Stage 1 Road Safety Audit Designers Response

Cabbagefield Row,

Swanmore Road,

Leigh Park

Drawing Title:
ACCESS ROUTES VEHICLE ACCESS JUNCTION SOUTH (SWANMORE ROAD)

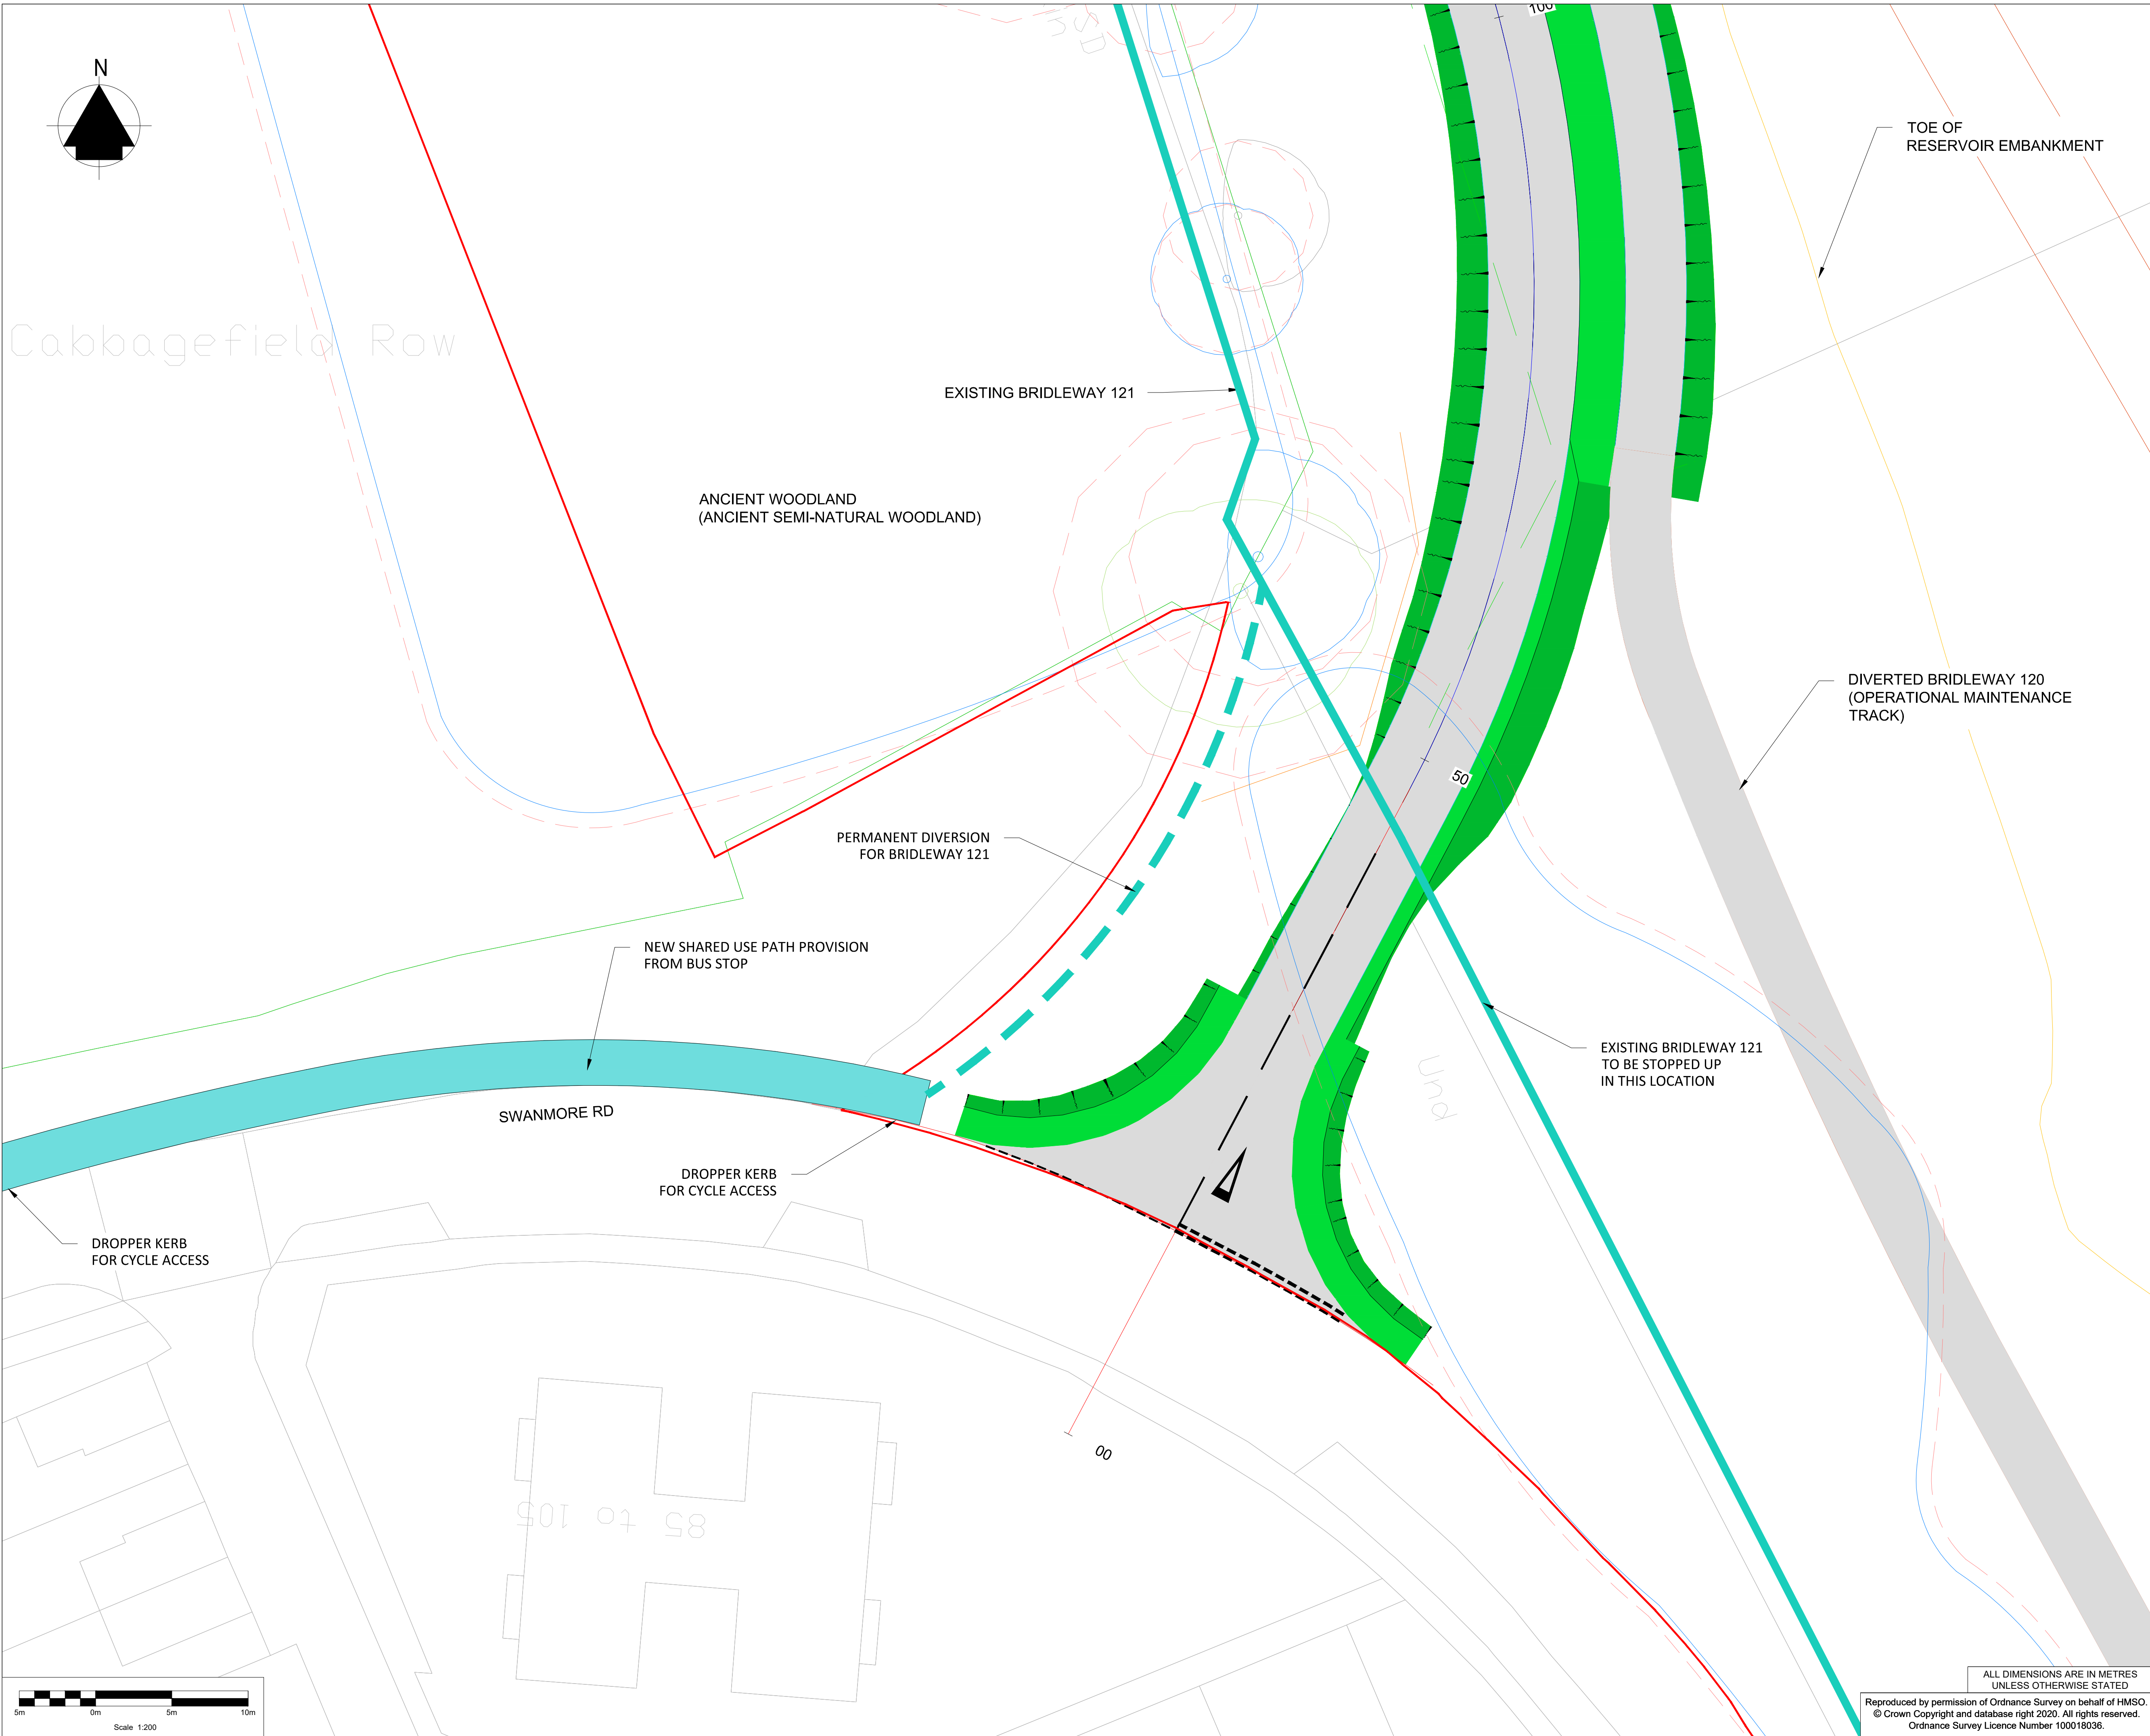
3.1.2	Shared cycle path / footway and existing carriageway	The plans do not indicate where the existing cycle path (located on the carriageway) will be provided and how cyclists will join the new shared footway. There was concern during the site investigation regarding where cyclists will adjoin the shared cycleway / footway from the existing carriageway. The existing cycle lane appears confusing in various parts and unclear on the expectation for a cyclist using the route. As a result of overall disjointed cycle facilities and confusing continuity, this could give rise to cyclist and driver conflict.	Provide sufficient dropped kerbs from the carriageway to the footway to allow cyclists to adjoin the cycle path. Review and extend the designated areas for cyclists to ensure that there is a clear strategy along the entire route.	Agreed, additional dropped kerbs added to allow adjoining. The shared use path is proposed on the northern side of Swanmore Road up to the bus stops as requested by HCC to link with the approved Havant Thicket proposals. The cycle path would expect to link with Havant Thicket drawing number HTR-ATK-AR-RE-DR-D-0006 Vehicle Access Junction South revC04 included at Appendix B for reference.

Access Plan

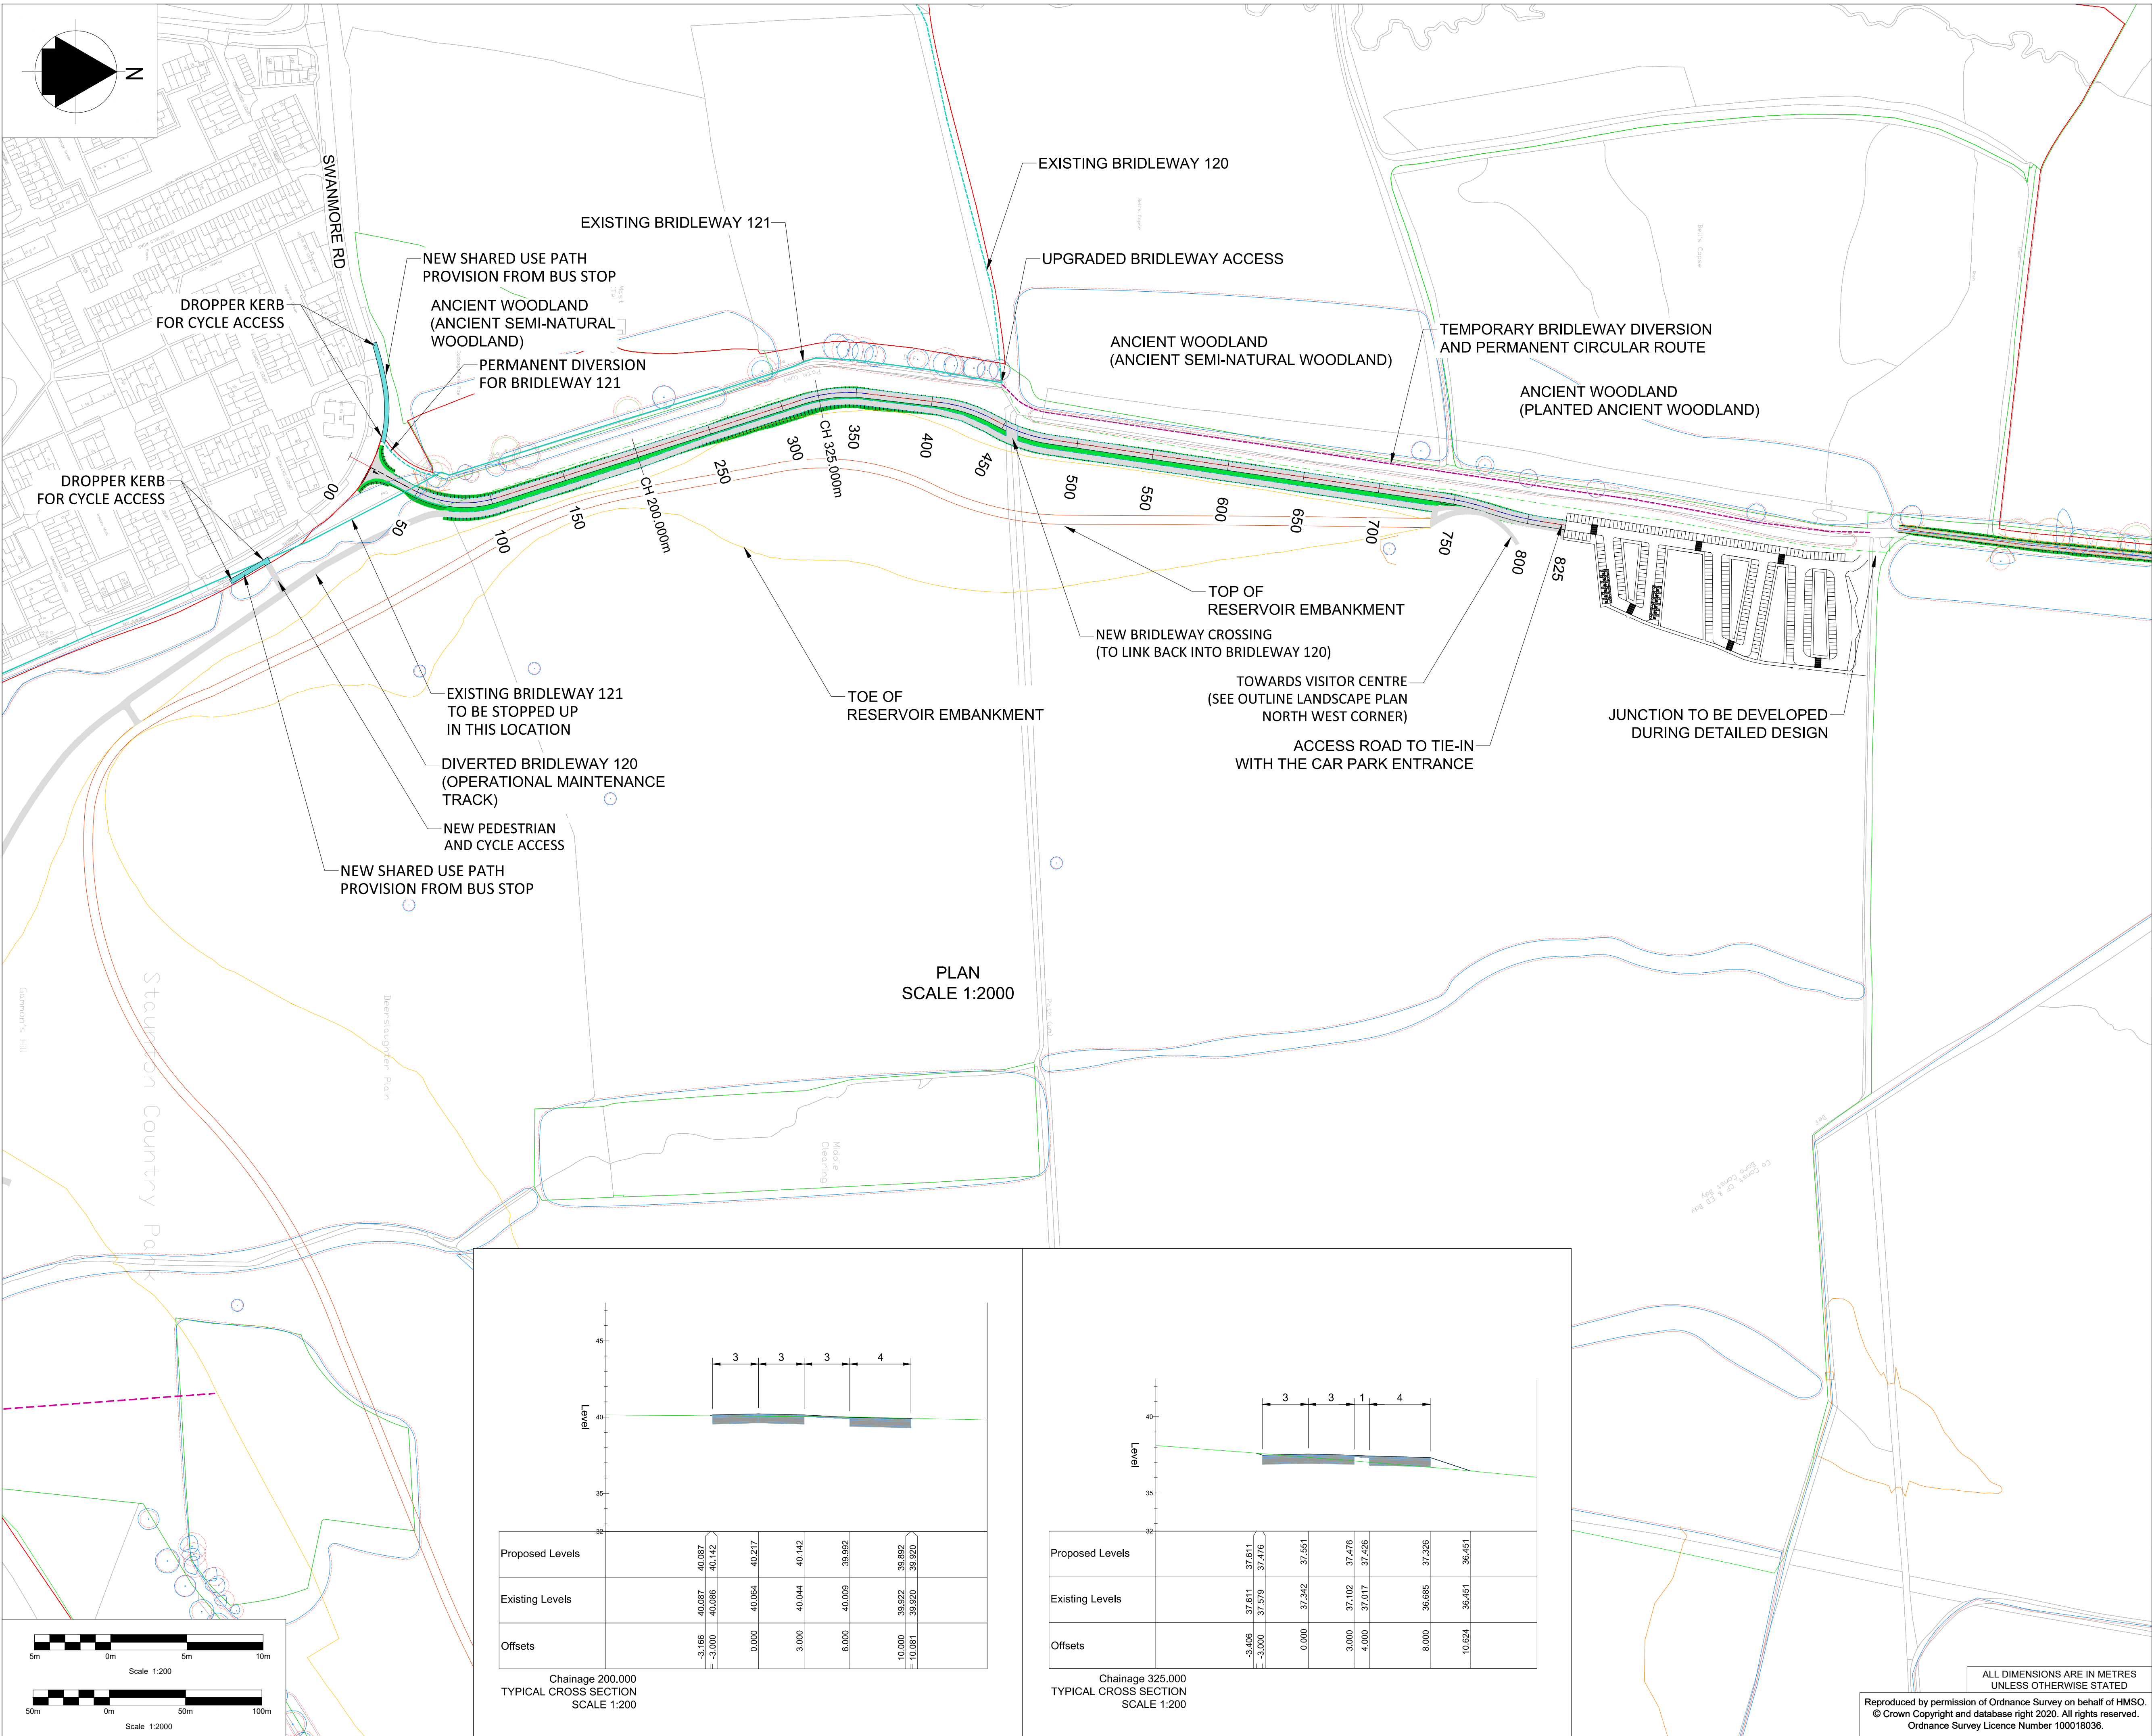
Problem	Location	Description	Recommendation	Designer's Response
3.1.1	Swanmore Road (northern side)	There are currently various items of street furniture in place where the new proposed footway will be provided. This includes lamp columns, signposts, overhanging vegetation and trees. The shared use path would require a level surface and one without pinch points and obstructions. If these are not relocated to suitable positions, they would be a road safety concern resulting in injury to cyclists or pedestrians.	Footway obstructions to be removed and street furniture to be relocated where appropriate.	Agreed – Relevant street furniture will be relocated accordingly and will be included at the detailed S278 design stage.

3.3.1	Various junctions within the proposed development	A visibility splay plan has been provided to the Audit Team that shows the forward visibility and general sightlines at each junction. Whilst it would be expected vehicle speeds would be low within the development, drivers will be required to give way on the approach to each junction with the 'main' through road or 'spine' road running through the development. However, the plan indicates new trees and planting close to the junctions. It is unclear at this stage the size of the proposed trees and the type. Many of the sightlines appear to be obstructed by such trees and as such could result in drivers failing to give way to oncoming vehicles. This could risk side swipe collisions occurring.	Trees removed from sightlines to always ensure good and unobstructed visibility.	Agreed, vegetation would be removed and is likely to be a condition of planning consent that visibility splays should be maintained.

- 3.1 There were 3 problems raised through the RSA1 process, all of which have been resolved at this stage. The relevant design amendments have been included on the access plan at Appendix A. Therefore, the RSA1 has not raised any fundamental problems that cannot be resolved.
